Redline Markups

2023 City of Seattle Standard Plans for Municipal Construction

The Standard Plans shown here depict the proposed edits of the 2020 Standard Plans used to create the 2023 Construction Standards.

City of Seattle	NOT TO SCALE	FIRE HYDRANT LOCATIONS & CLEARANCES

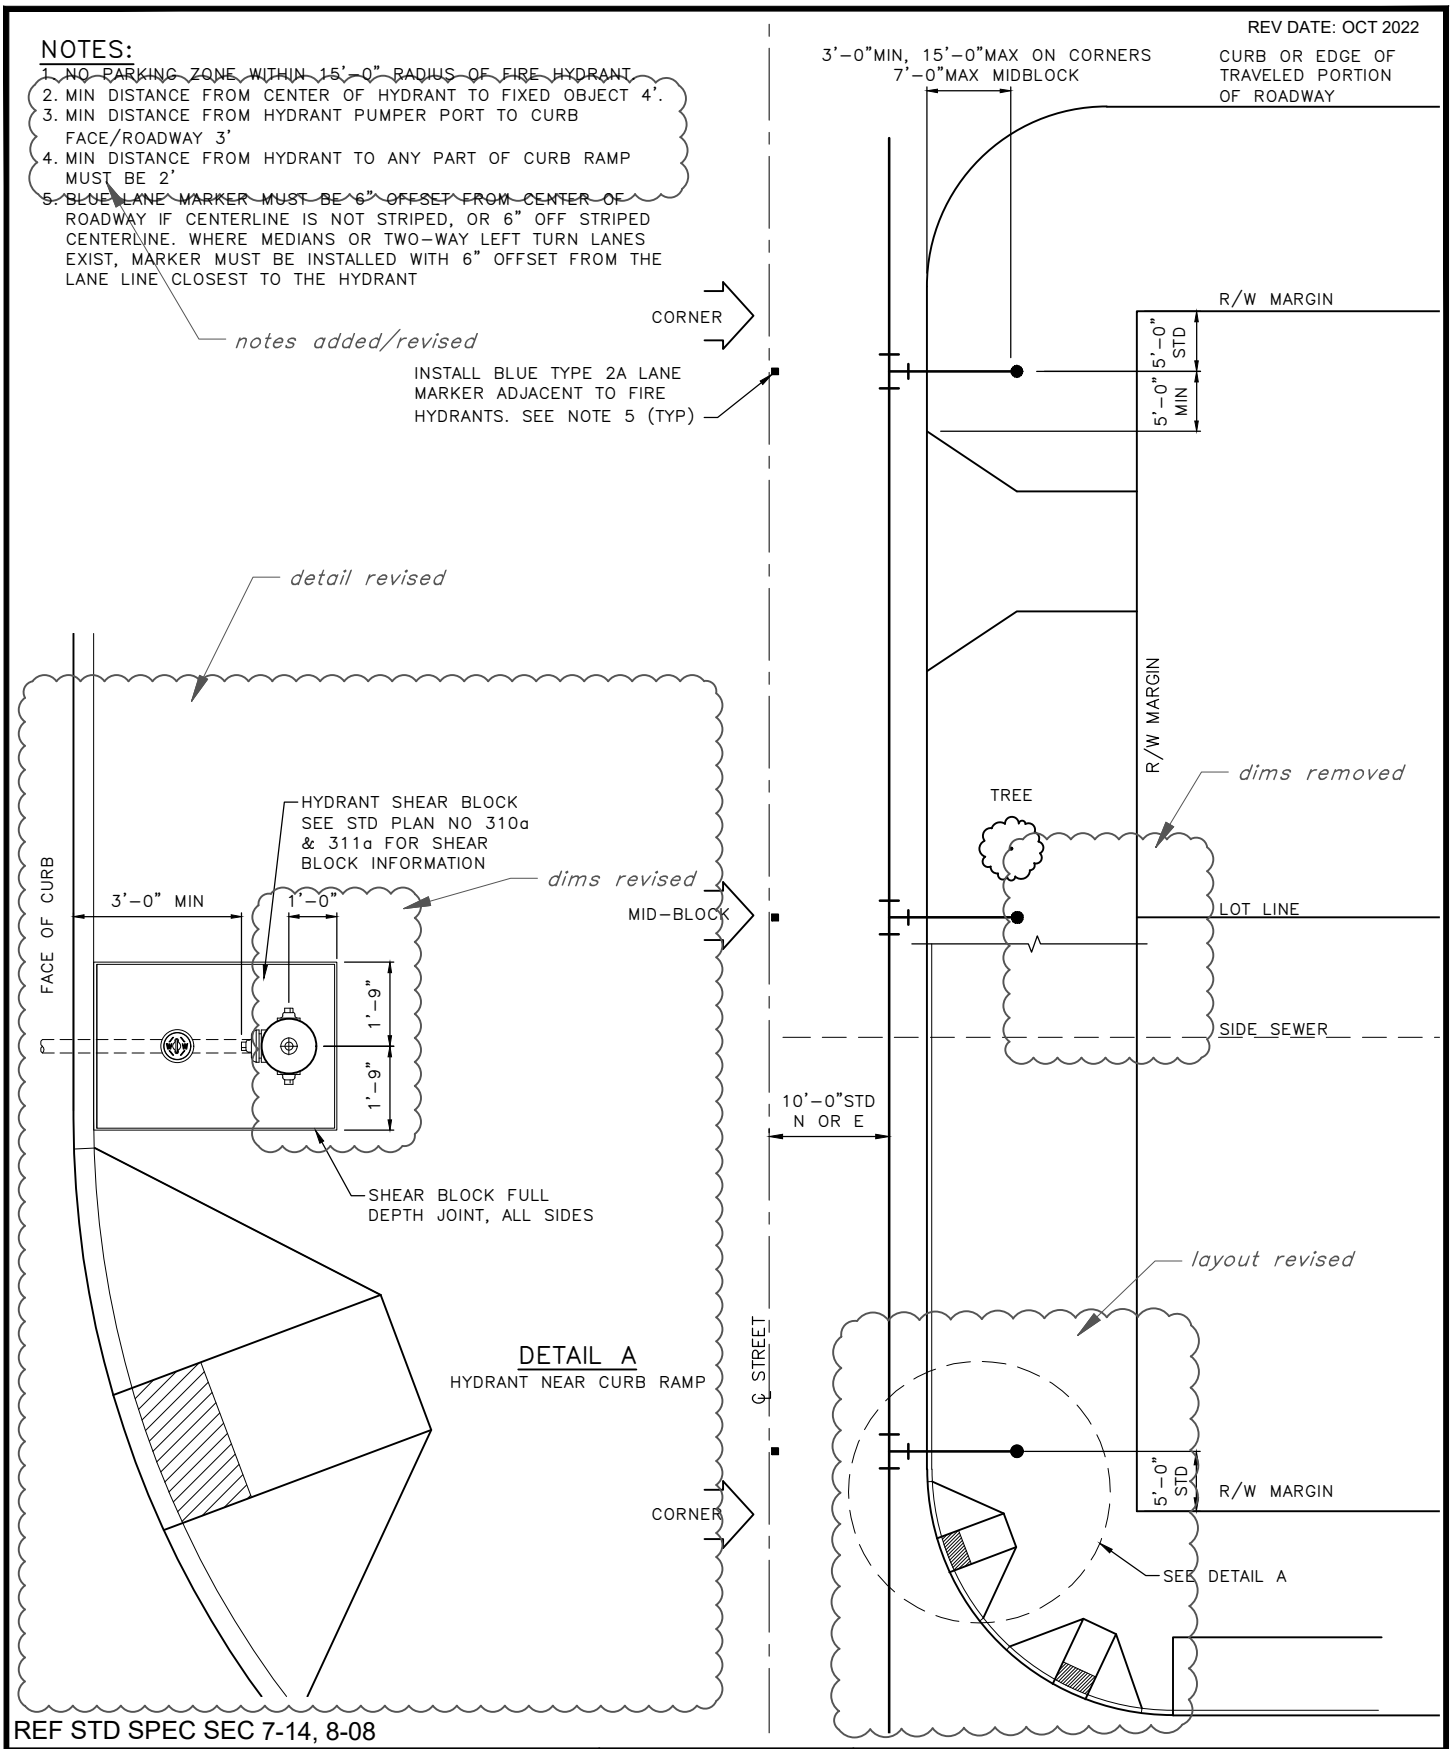
notes added/revised

NOTES:
1. NO PARKING ZONE WITHIN 15'–0" RADIUS OF FIRE HYDRANT
2. MIN DISTANCE FROM CENTER OF HYDRANT TO FIXED OBJECT 4'.
3. MIN DISTANCE FROM HYDRANT PUMPER PORT TO CURB FACE/ROADWAY 3'
4. MIN DISTANCE FROM HYDRANT TO ANY PART OF CURB RAMP MUST BE 2'
5. BLUE LANE MARKER MUST BE 6" OFFSET FROM CENTER OF ROADWAY IF CENTERLINE IS NOT STRIPED, OR 6" OFF STRIPED CENTERLINE. WHERE MEDIANS OR TWO–WAY LEFT TURN LANES EXIST, MARKER MUST BE INSTALLED WITH 6" OFFSET FROM THE LANE LINE CLOSEST TO THE HYDRANT

CLEARANCES FOR TYPICAL WATER SERVICE VAULTS

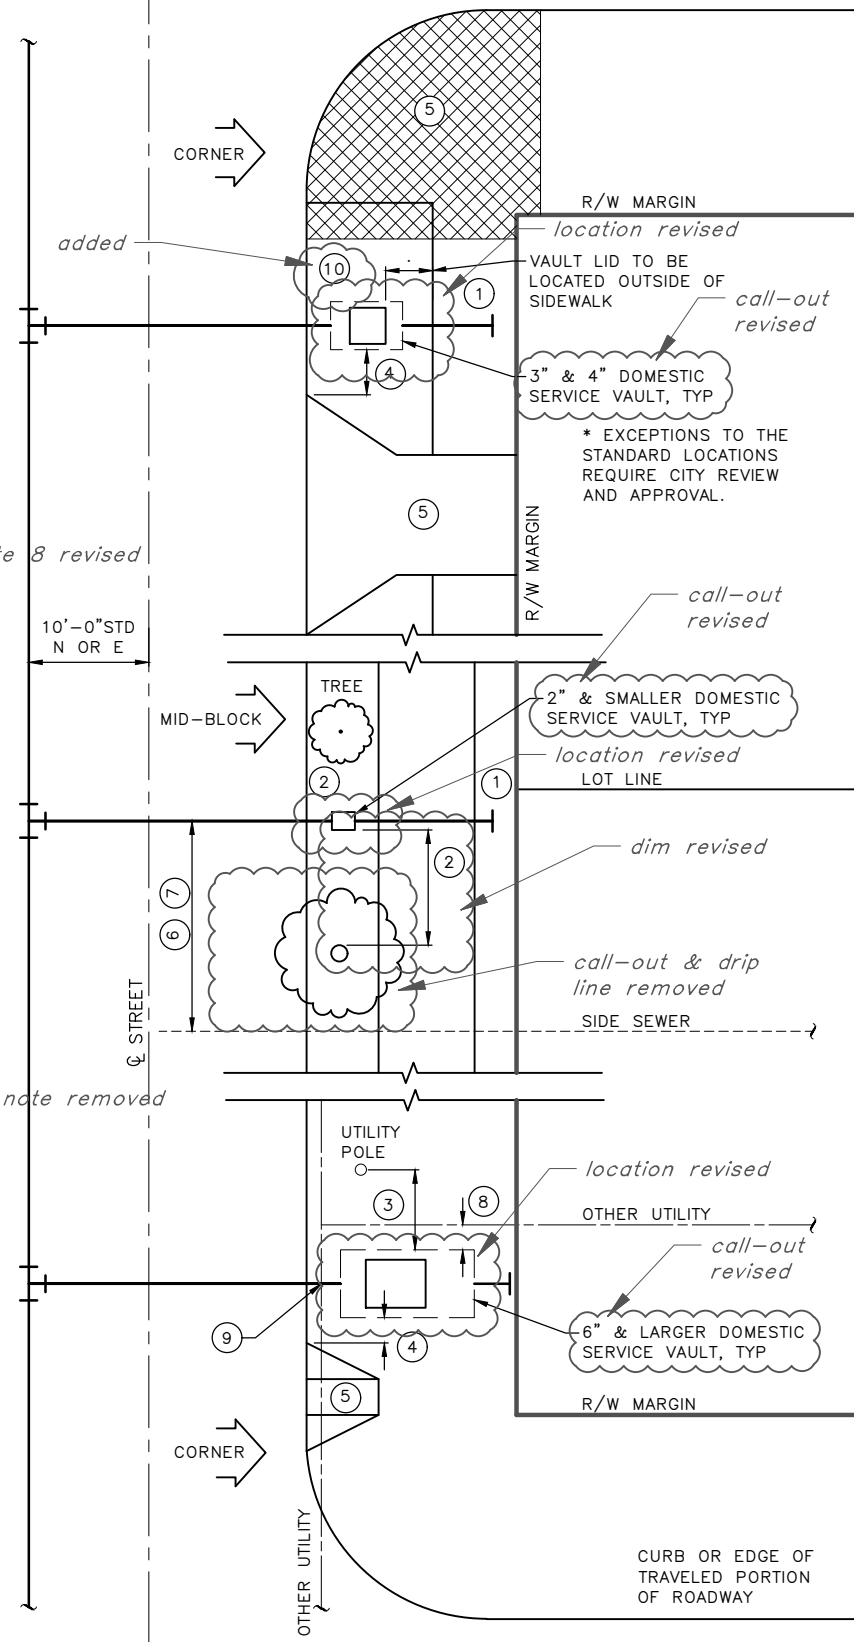
notes 1 & 2 revised

notes added

note 8 revised

note removed

1. UNION POINT 2' OUTSIDE OF VAULT UNLESS OTHERWISE NOTED ON PLANS.
2. 5' CLEARANCE MINIMUM FROM NEW OR EXISTING TREES. IF EXCAVATION IS REQUIRED WITHIN ROOT ZONE OF EXISTING TREES, THE EXCAVATION MUST BE ACCOMPLISHED BY HAND METHODS, CONDUCTED TO PREVENT DAMAGE TO FEEDER AND SURFACE ROOTS, AND MINIMIZE COMPACTION SOILS.
3. ~~5' CLEAR FROM POLES.~~
4. 2' CLEAR FROM EDGE OF DRIVEWAY OR ADA RAMP.
5. WATER SERVICE NOT TO BE INSTALLED IN DRIVEWAY, BEHIND ADA RAMP, OR STREET CORNER.
6. SIDE SEWER HORIZONTAL CLEARANCE 10' FOR CAST IRON WATER PIPE OR 5' FOR DUCTILE IRON WATER PIPE.
7. SIDE SEWER VERTICAL CLEARANCE 1.5' MIN.
8. VAULT HORIZONTAL CLEARANCE 3' MIN FROM OTHER UTILITIES. UNLESS OTHERWISE NOTED IN STD SPECS.
9. VERTICAL CLEARANCE 12" MIN FOR ALL OTHER UTILITY CROSSINGS UNLESS OTHERWISE NOTED IN STD SPECS.
10. ALLOWABLE LOCATION OF WATER SERVICE VAULT, 2' MINIMUM CLEAR OF CURB.

~~PERMIT REQUIREMENTS WILL DETERMINE LOCATION AND ORIENTATION OF ALL SERVICE VAULTS IN THE RIGHT OF WAY. VAULTS SHOWN ON THIS STD PLAN ARE FOR GRAPHICAL PURPOSES ONLY.~~

City of Seattle | NOT TO SCALE | WATERMAIN TRENCH AND BEDDING

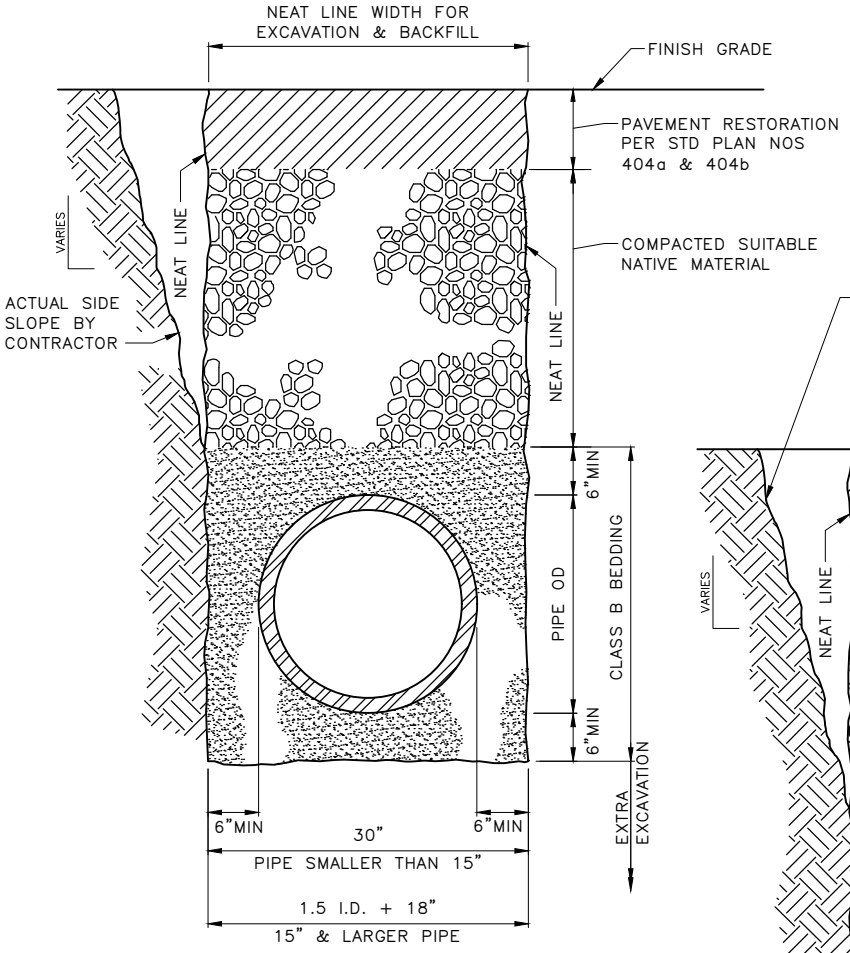
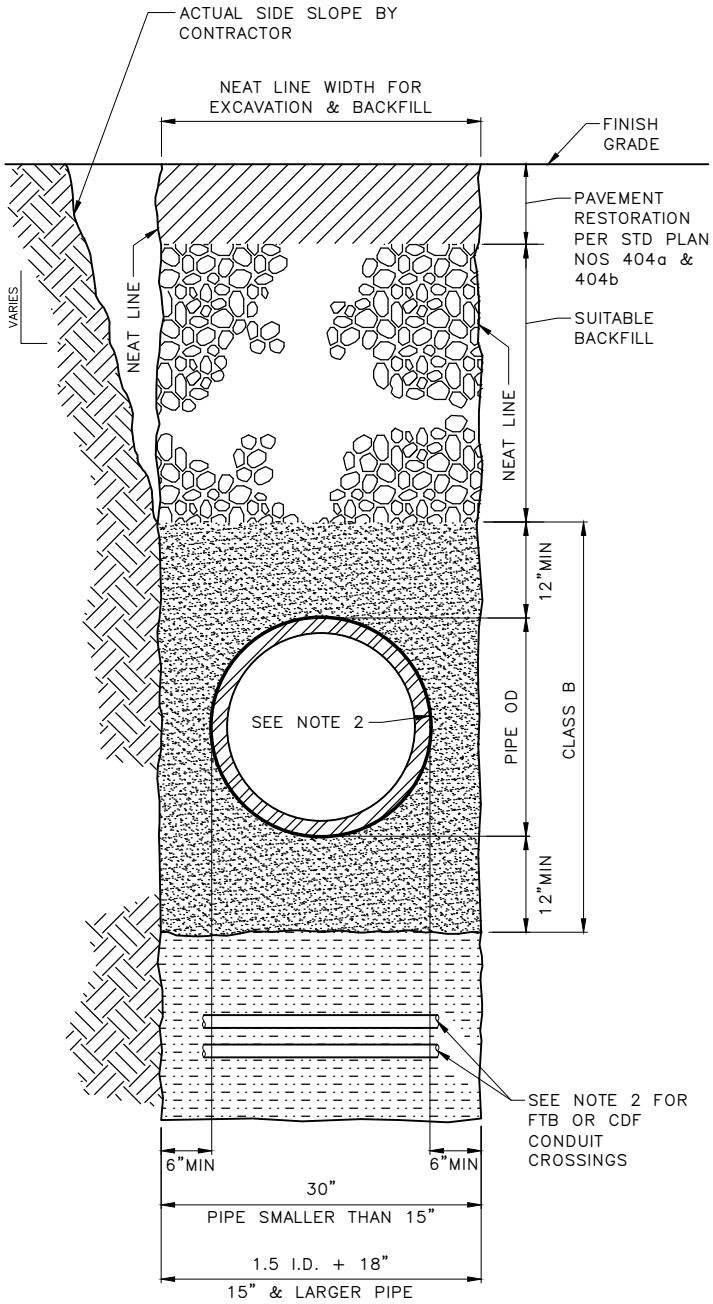
revised from 9-03.16

9-03.16 removed

- FOR DISTRIBUTION WATERMAIN, MINERAL AGGREGATE PER STD SPEC 9-03.14 TYPE 6 OR TYPE 7
- FOR TRANSMISSION WATERMAIN, MINERAL AGGREGATE PER STD SPEC 9-03.14 TYPE 9
- SPECIAL BEDDING TO BE INDICATED ON DRAWINGS

City of Seattle | NOT TO SCALE | ROADWAY CONCRETE PAVEMENT JOINTS

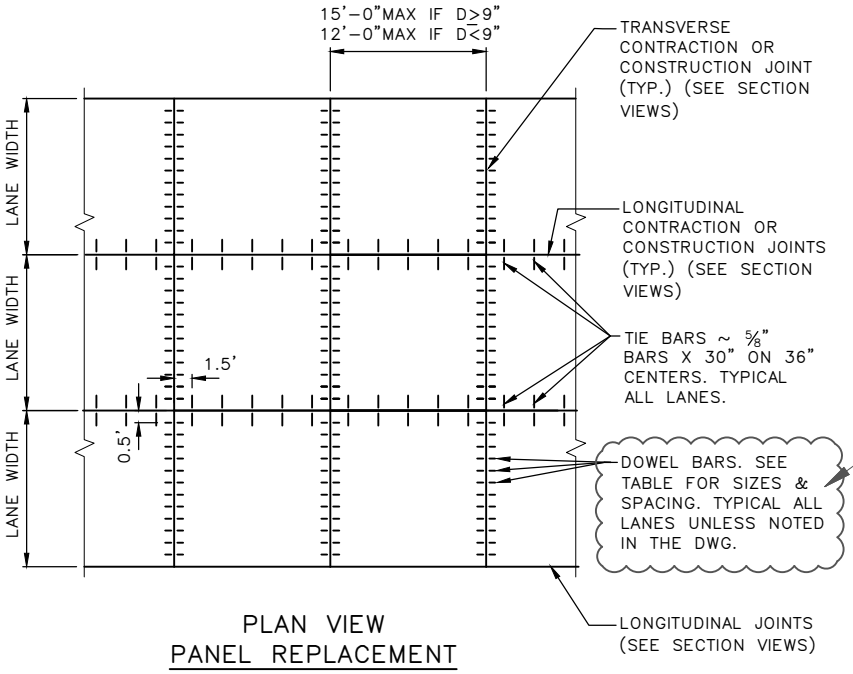
callout revised

table revised

callouts revised

DEPTH (D) OF RDWY CEM. CONC	SOLID STEEL DOWEL BAR SIZE OUTSIDE DIAMETER (OD) X LENGTH (L) @ ON CENTER (OC)	TUBULAR DOWEL BAR SIZE OUTSIDE DIAMETER (OD), WALL THICKNESS X LENGTH (L) @ ON CENTER (OC)
6" ≤ D <9"	1.00" OD X 18" L @ 12" OC	1.375" OD, 0.120: MIN X 18" L @ 12" OC
9" ≤ D <11"	1.25" OD X 18" L @ 12" OC	1.375" OD, 0.120: MIN X 18" L @ 12" OC
11" ≤ D	1.50" OD X 18" L @ 12" OC	1.625" OD, 0.120: MIN X 18" L @ 12" OC

City of Seattle	NOT TO SCALE	TYPE 410 CURB

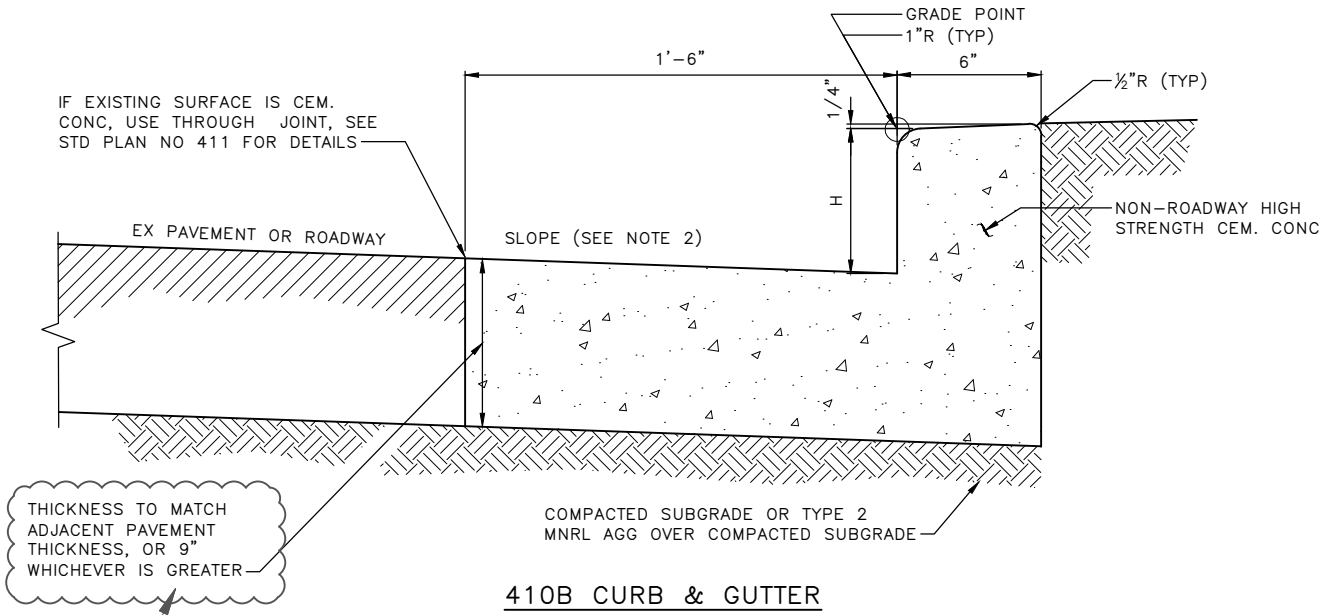
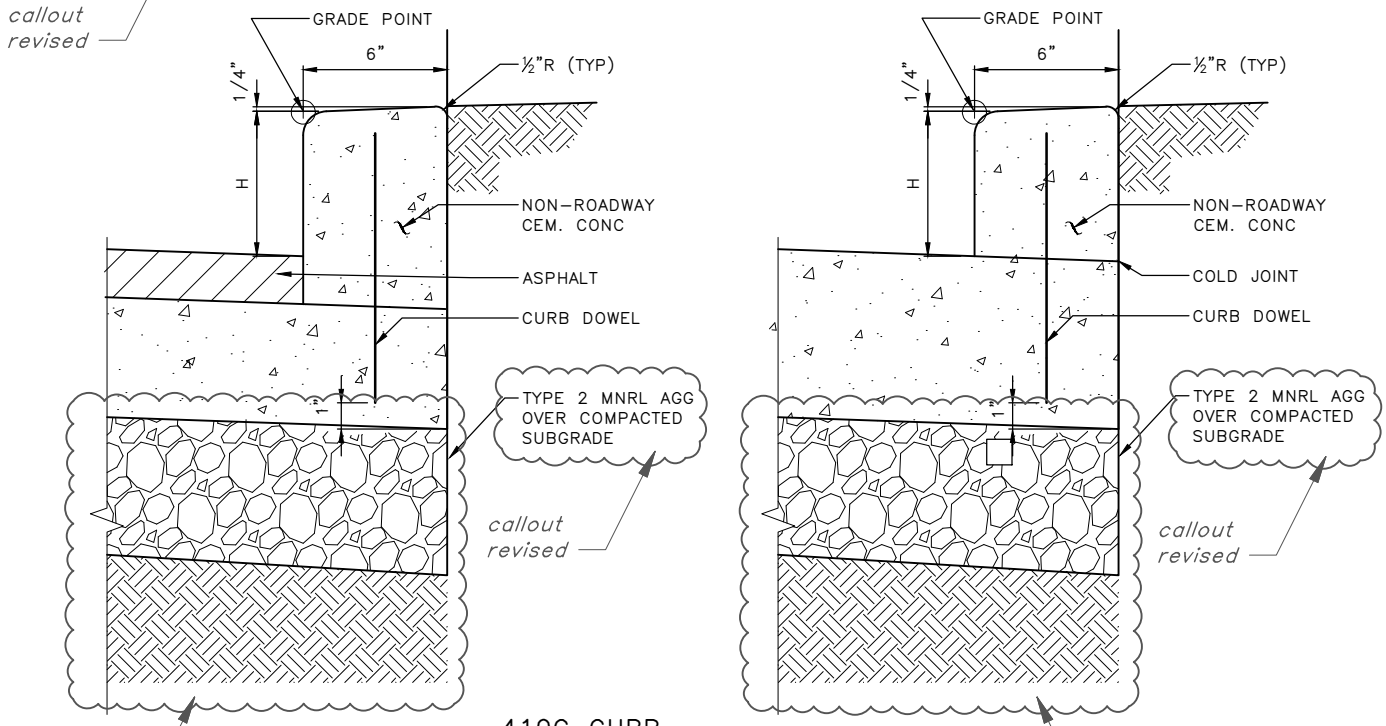
callout revised

callout revised

callout revised

subgrade revised

subgrade revised

City of Seattle	NOT TO SCALE	EXPANDABLE TREE PIT DETAIL

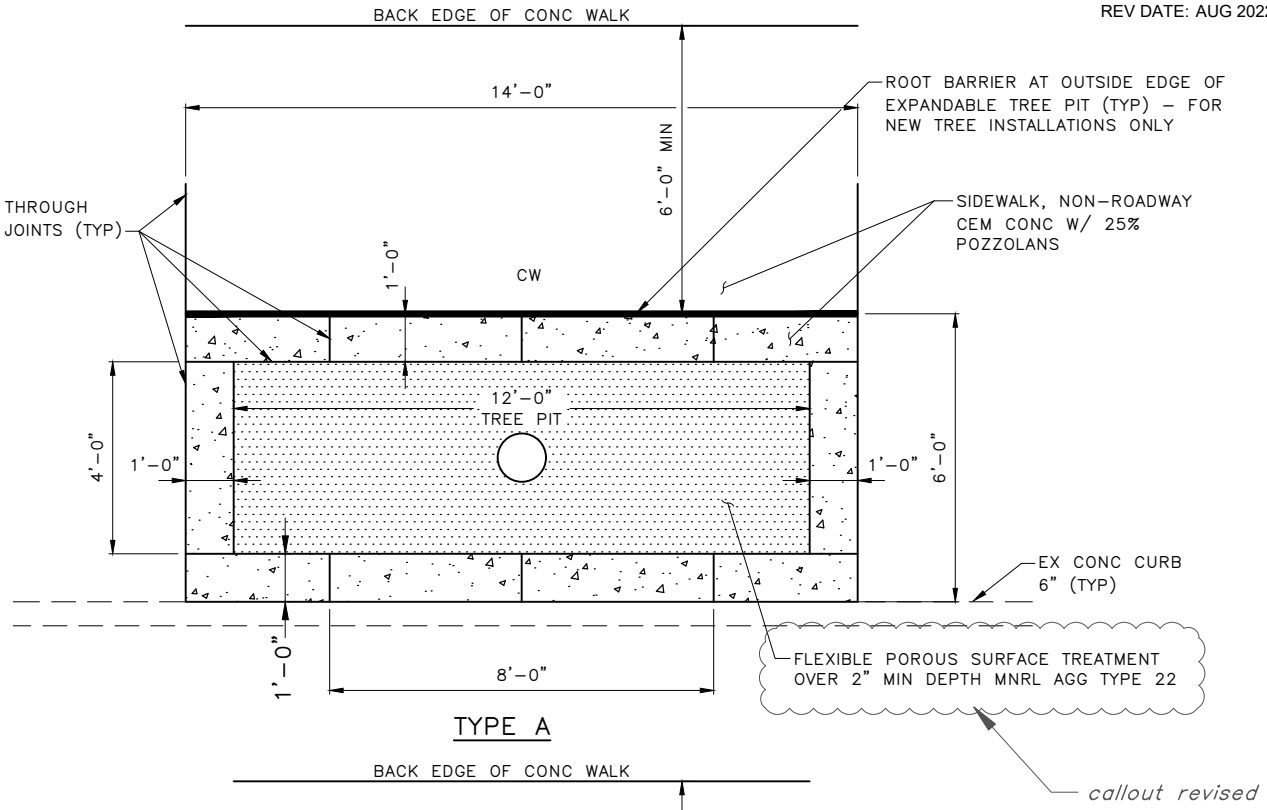
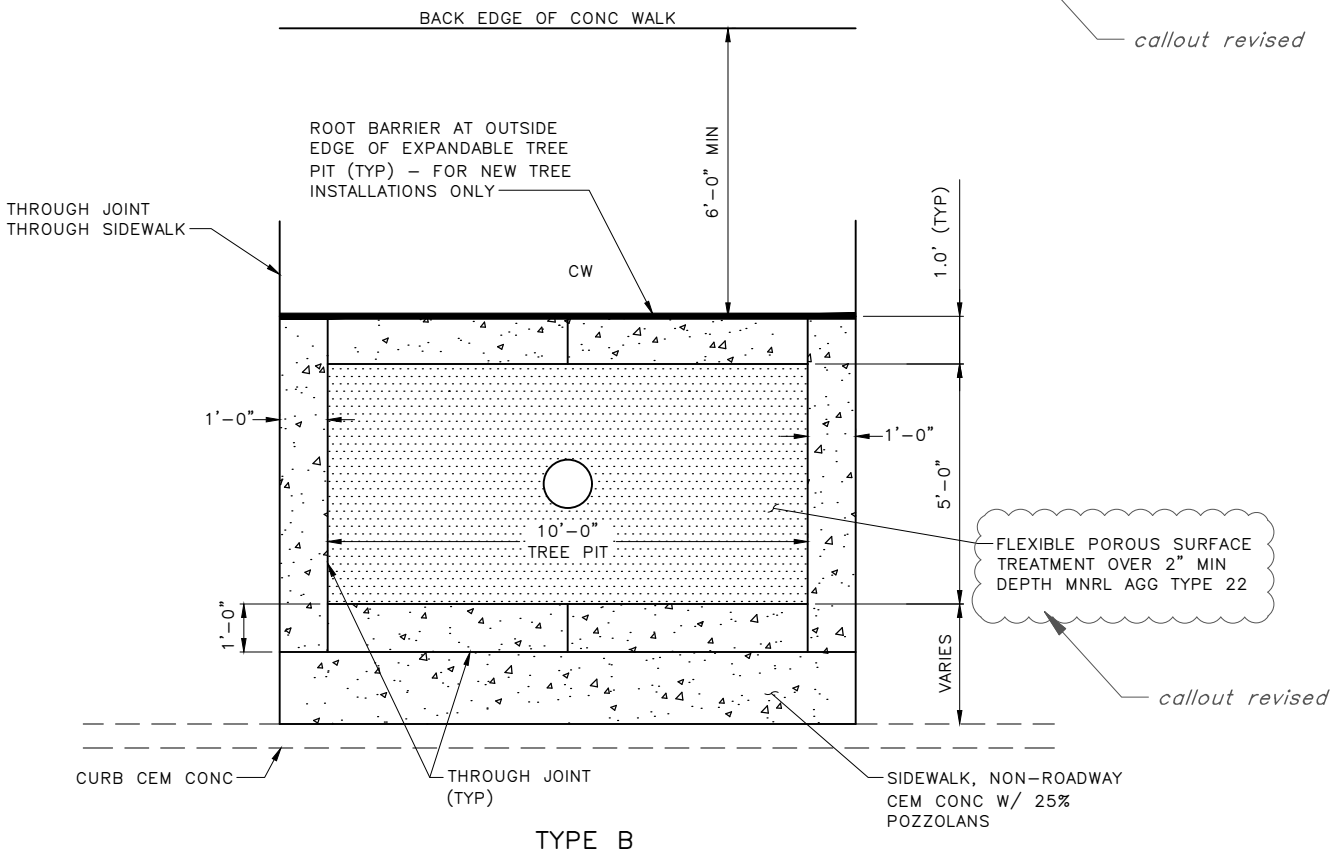
callout revised

callout revised
